Subject: License No: UT2300249; RML #UT 2300249 –Condition 35 Compliance Report, Revision 1; **Responses to February 2014 Round 1 Interrogatories**

**RESPONSES TO 28 FEBRUARY 2014 – ROUND 1 INTERROGATORIES
UTAH LLRW DISPOSAL LICENSE RML UT 2300249
CONDITION 35 COMPLIANCE REPORT**

ENERGYSOLUTIONS
 CLIVE FACILITY
 FEDERAL WASTE CELL
 PROJECT TITLE SHEET
 CLIVE, UTAH

Figure 2-02/1, Uranium-238 Decay Series

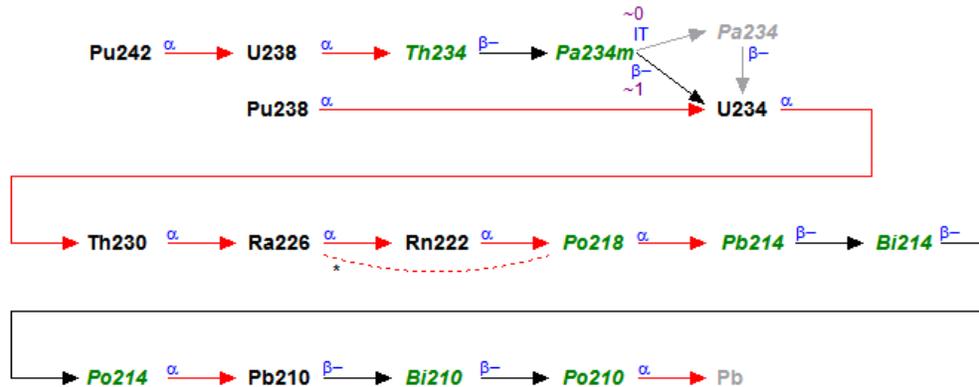
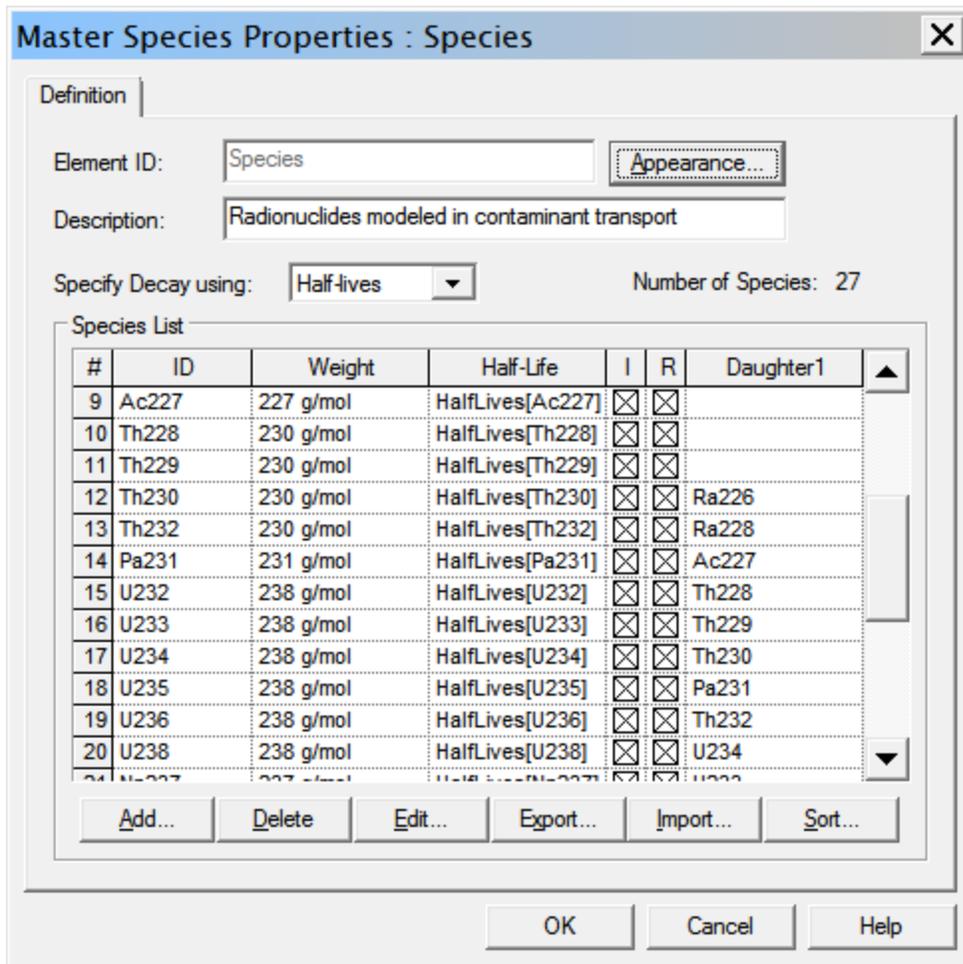
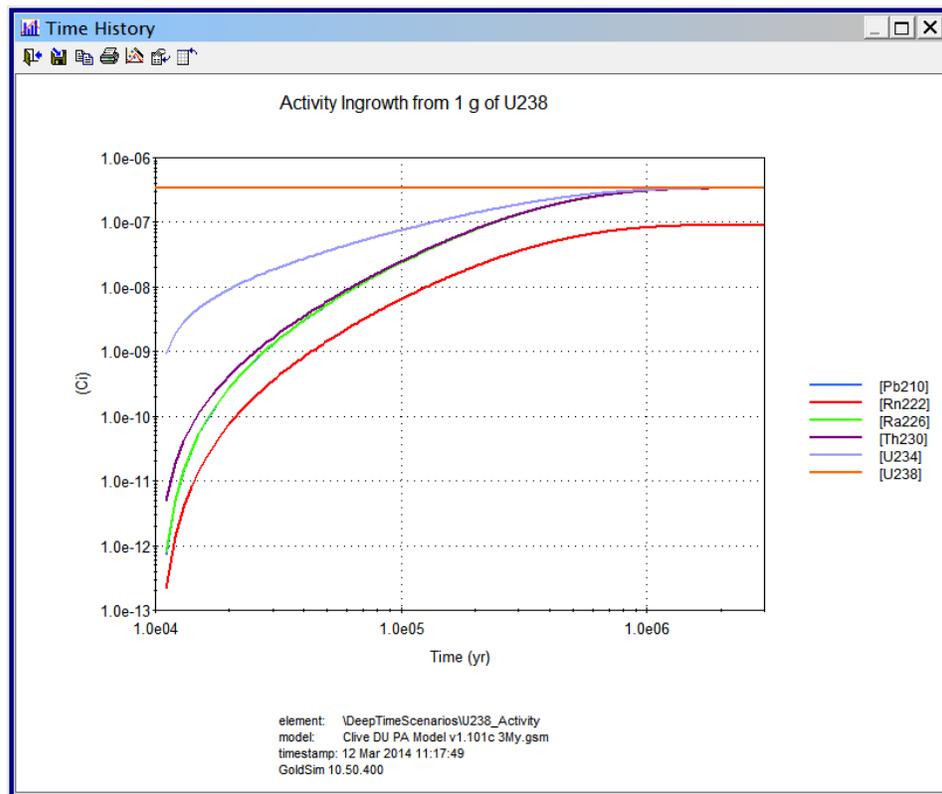
Provide further information on how the length of the deep time assessment (2.1 million years (My)) was determined.

EnergySolutions’ Response: Radioactive decay and ingrowth in a given decay chain is calculated using the Bateman equation,

however this matters not for the determination of the time of secular equilibrium. The half-lives and direct progeny for each member of the chain are implemented in the Species element, in the \Materials container, a screen shot of which is shown.

The GoldSim software uses this information to solve the Bateman equation internally, thereby producing values for abundance of all members of the chain at any time. In order to illustrate this, a special calculation is executed in the Clive DU PA Model in the \DeepTimeScenarios container (see box on upper right part of the page in that container, labeled “A study of the decay and ingrowth from U-238”). Two result elements in that box show the abundance of all modeled radionuclides, having started with 1 g of U-238 in the “UnitInventoryU238” cell. One result element shows abundance in units of mass (g), and the other in units of activity (Ci). The latter is shown here and illustrates how all members of the chain gradually come into equilibrium with the U-238 parent. Therefore, they all achieve the same activity. Radon is the exception, due to how its E/P ratio is implemented in this model, but this has no implications for the determination of secular equilibrium.

As can be seen in this graph of activity over time, secular equilibrium is reached at just over 2 My. At 2.1 My, the abundance of the last modeled member of the chain, Pb-210, is equal to that of ^{238}U , within less than one half of one percent.

The text in the FRV1 Executive Summary, page 5 is being changed as follows to reflect that the decay products reach secular equilibrium with the major parent, U-238, and further explanation is being provided along the lines presented above.

ENERGYSOLUTIONS
 CLIVE FACILITY
 FEDERAL WASTE CELL
 CONCEPTUAL DU DISPOSAL PLAN
 CLIVE, UTAH

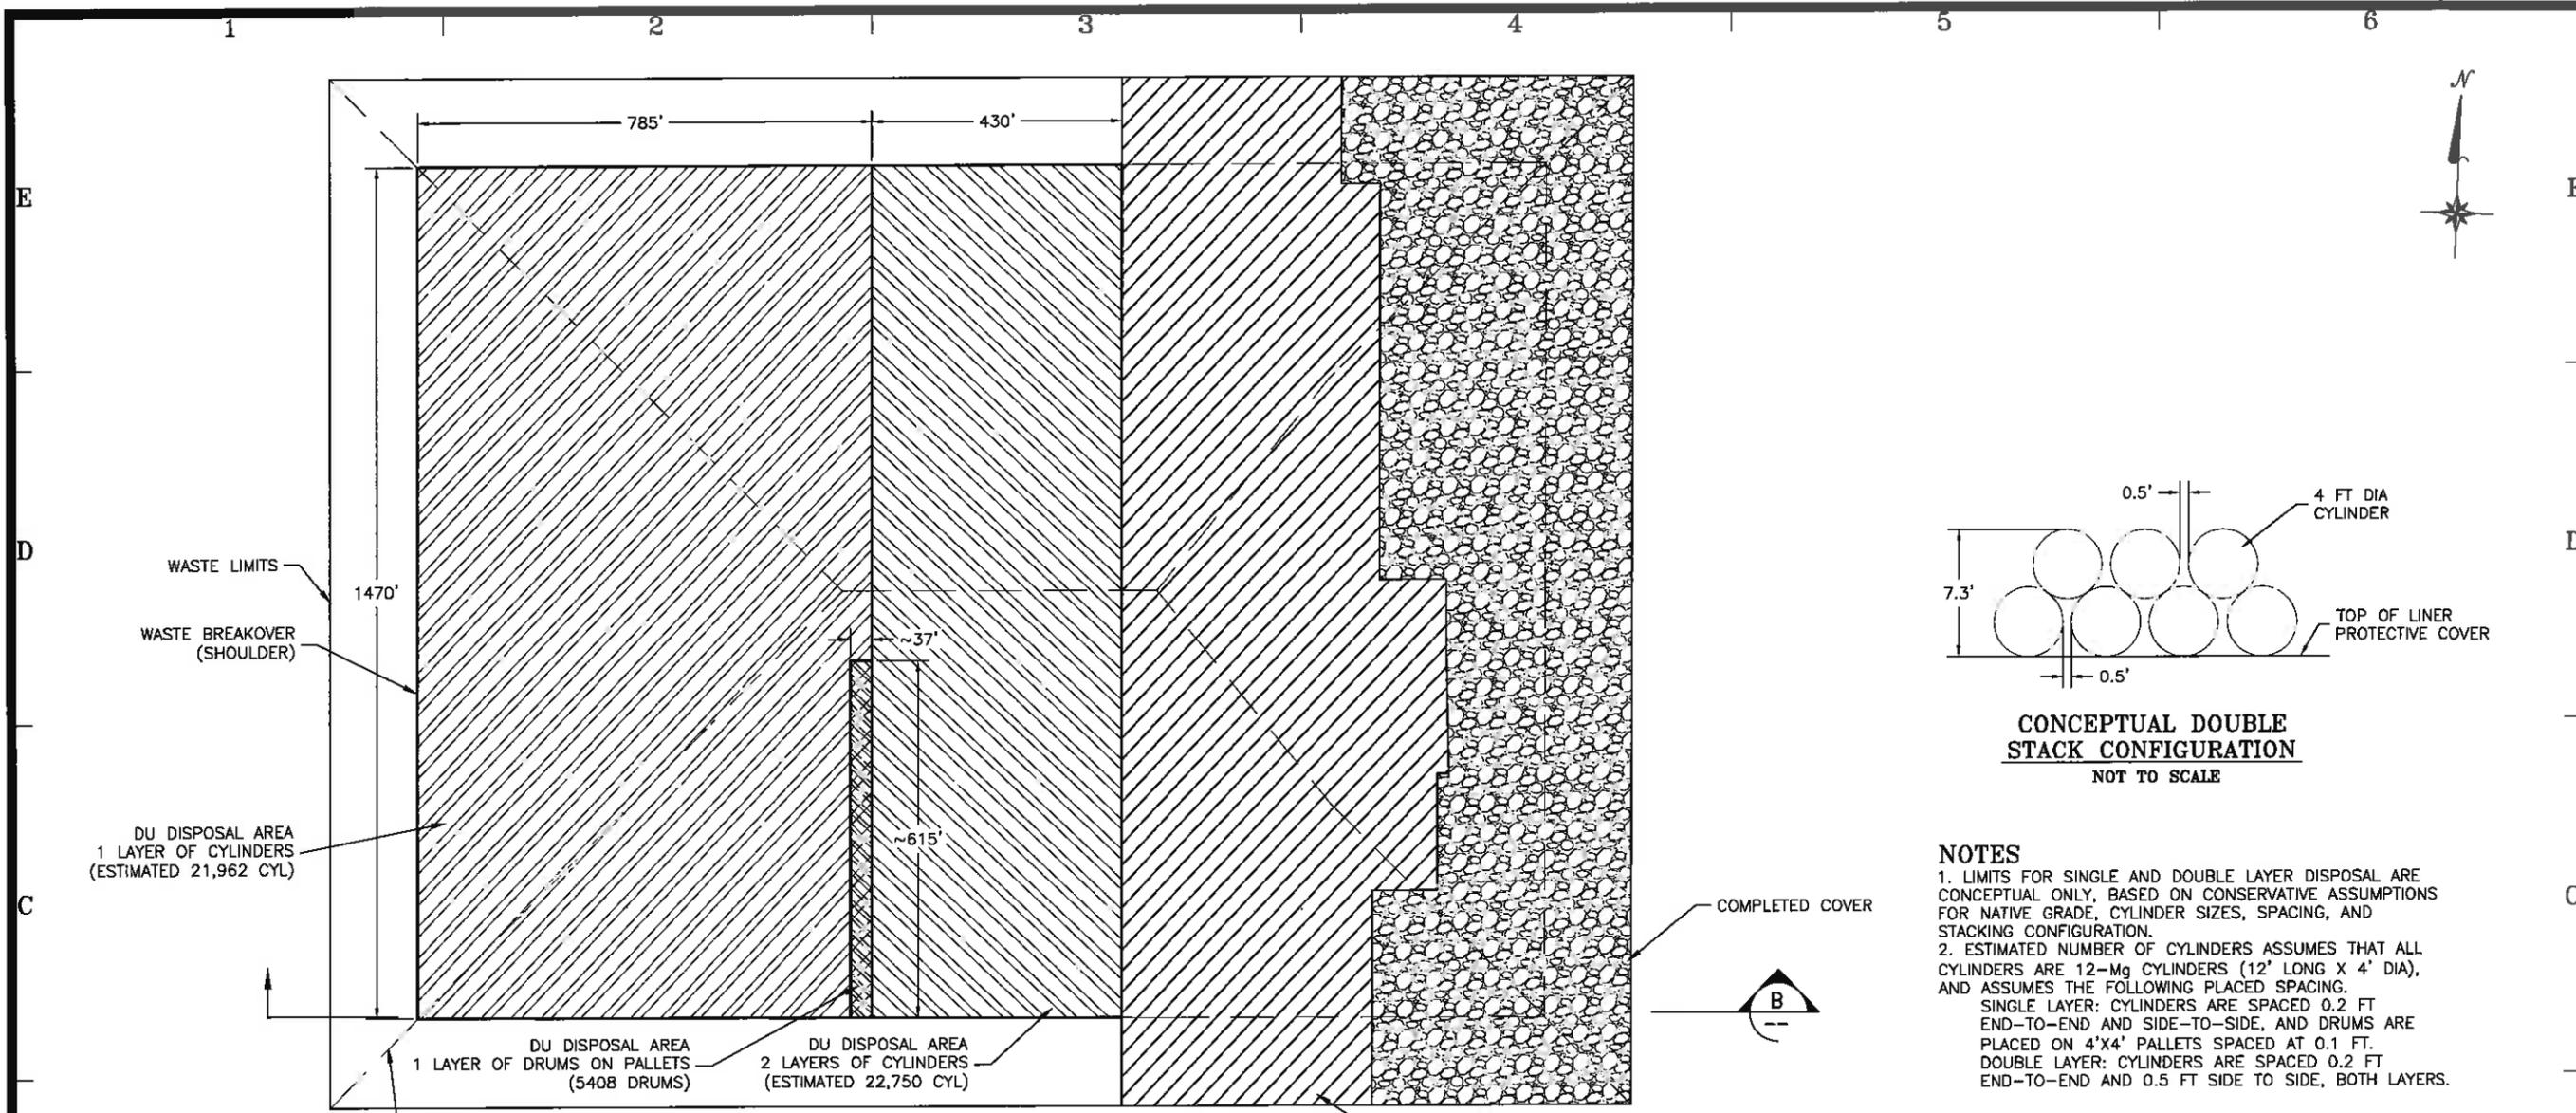
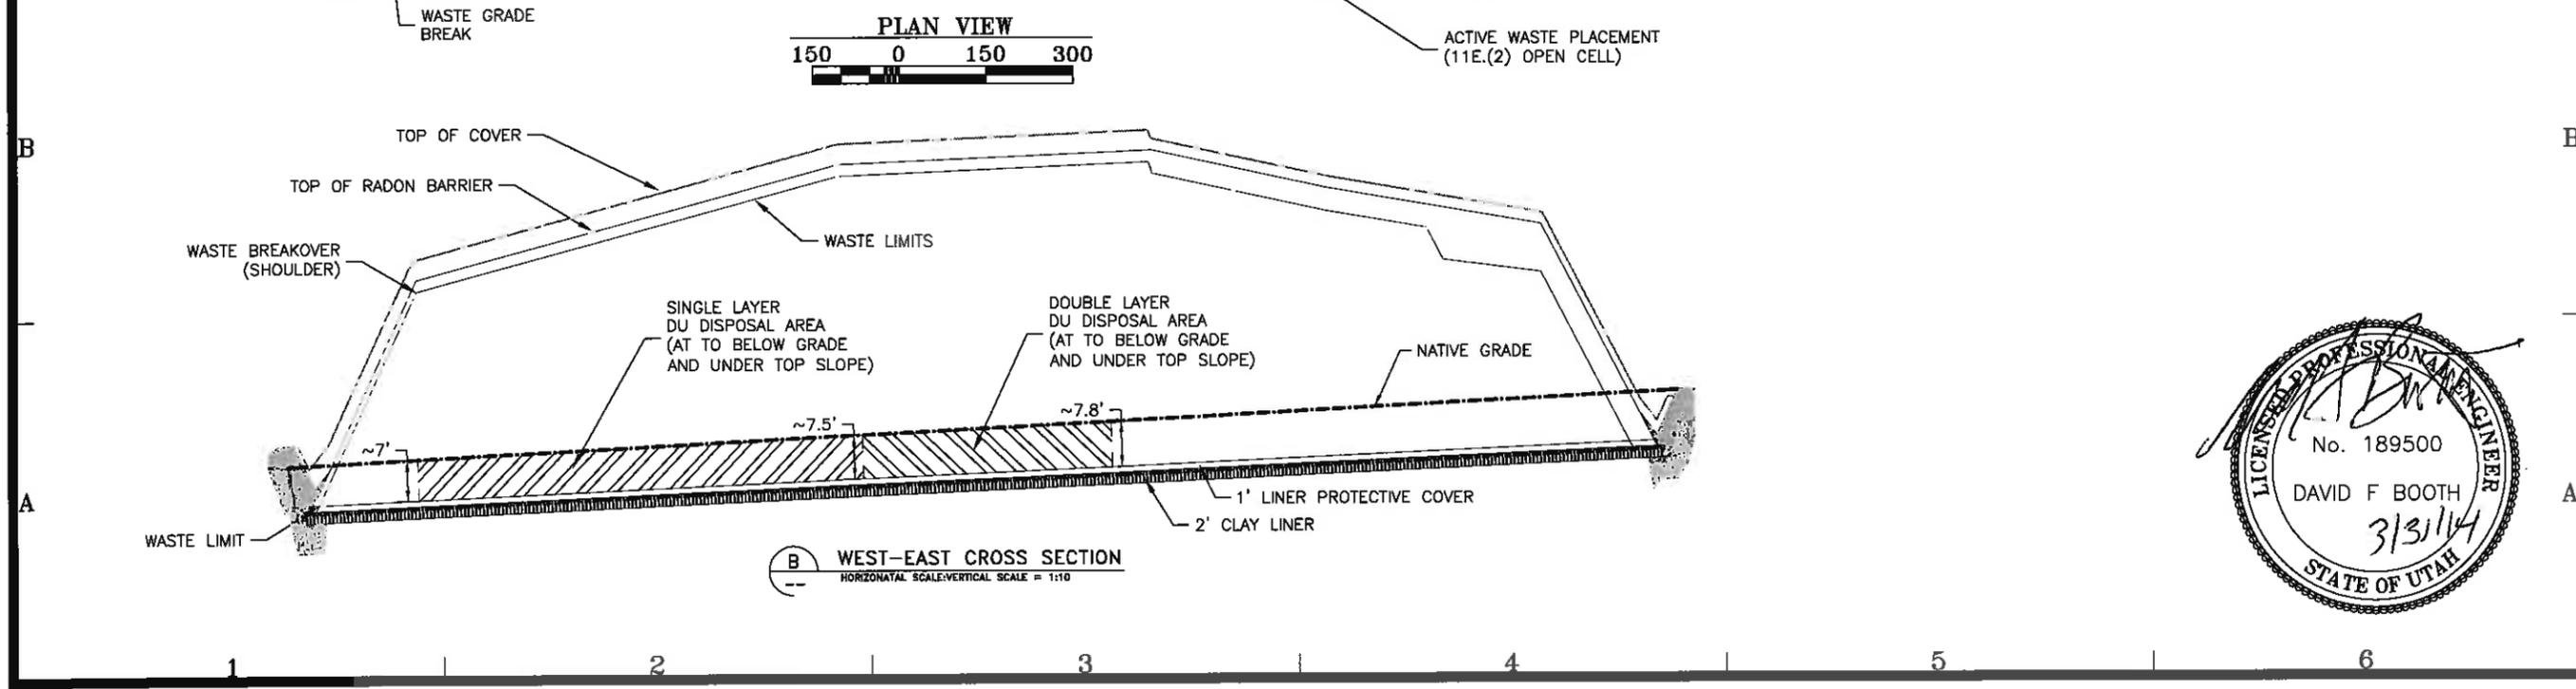
Explain how Figure 1-2 demonstrates that the entire inventory of DU can be disposed below grade. Provide calculations demonstrating that below-grade disposal will be achieved in the Federal Cell and that the burial depth is sufficient to protect the DU waste.

Resolve the conflicting statements about available thickness in the embankment for waste emplacement and emplacement depths. Explain and justify the plans given in the text of the PA given the information in Figure 1.2 and revise as necessary.

EnergySolutions' Response: Figure 1.2 has been clarified to reflect EnergySolutions' commitment that only a volume of depleted uranium that can be disposed of below grade in the Federal Cell will be managed, regardless of placement geometry.

EnergySolutions' Response: Figure 1.2 has been clarified to reflect EnergySolutions' commitment that only a volume of depleted uranium that can be disposed of below grade in the Federal Cell will be managed. Because
